REQUEST FOR INFORMATION	DATE: October 10, 2016	NO.: RFI-321
--------------------------------	-------------------------------	---------------------

Project Name: 15051-Webster University Interdisciplinary Science Building	Project No.: 15051
---	--------------------

Subject: Existing drain lines at EAB

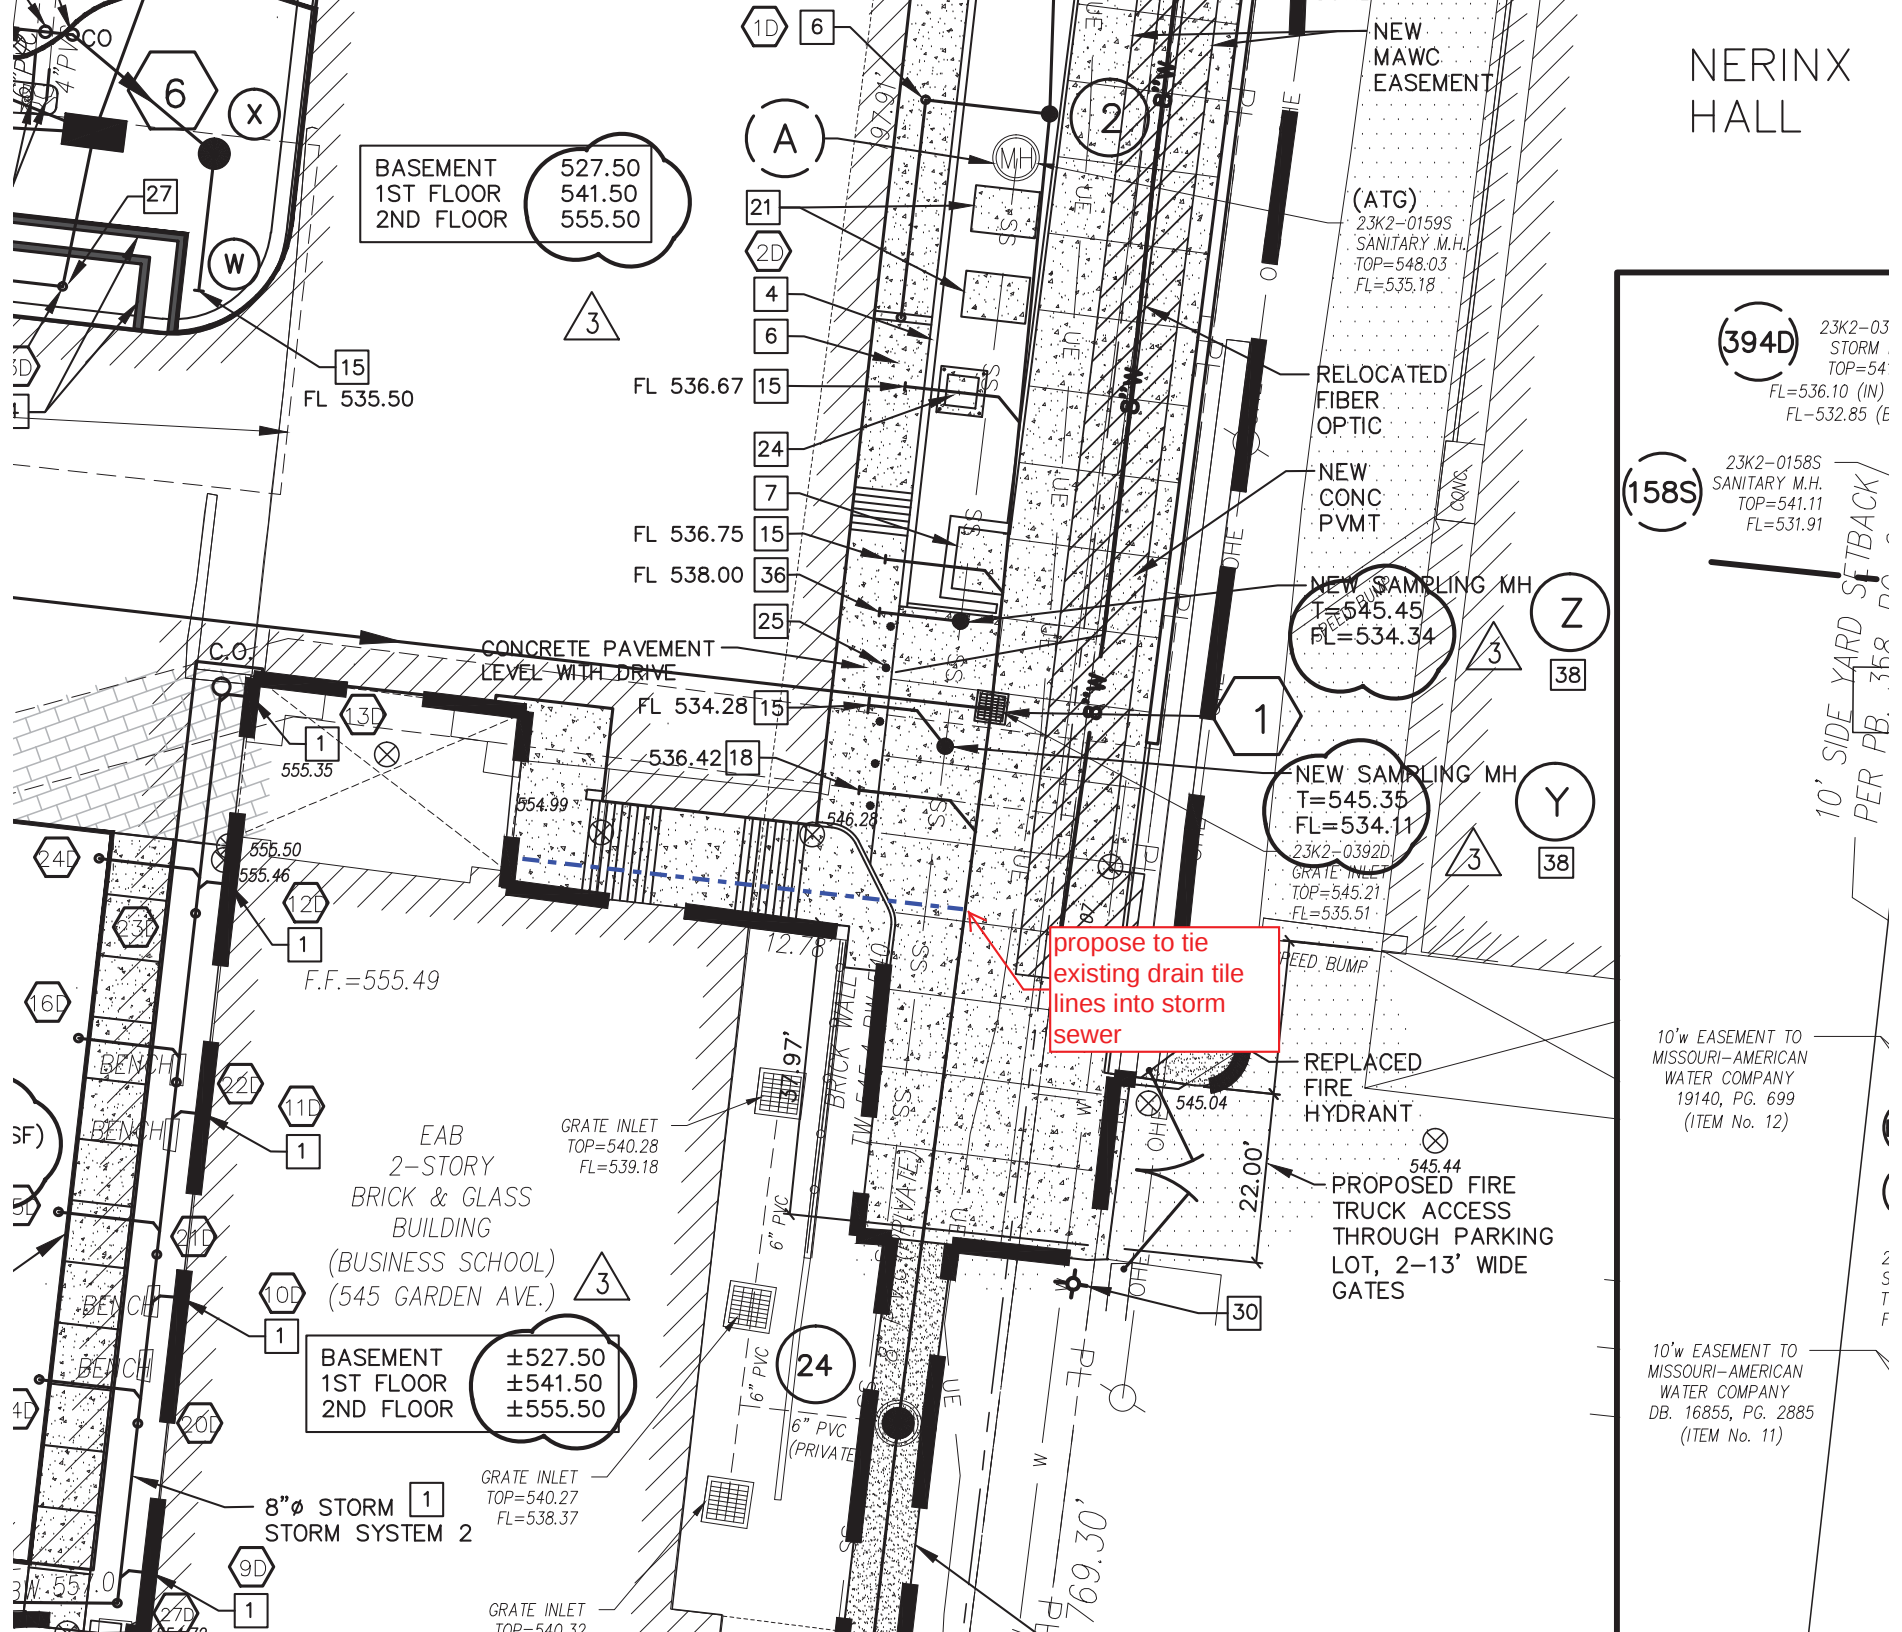
There are existing drain tile lines at the north of the EAB (see attached photos) that were dug up during demo of the stairs. Paric proposes to tie them into the storm sewer to the east as shown in the attached sketch. Please advise if this will be acceptable.

There is a drain in the portico on the north of the EAB which currently drains to the exterior of the building. Paric proposes to reroute the drain into an existing drain on the west of the building (see attached photo) and remove the drain line exiting the north of the building. Please advise if this will be acceptable.

PROPOSE TO TIE
INTO STORM
LINE

PROPOSE TO TIE
DRAIN INTO
ALTERNATE
INTERIOR LINE
(SEE OTHER
PHOTO) AND
PATCH HOLE.

PROPOSE TO
CUT PORTICO
DRAIN LINE AND
TIE INTO
EXISTING LINE
AS SHOWN

Both suggestions are acceptable.
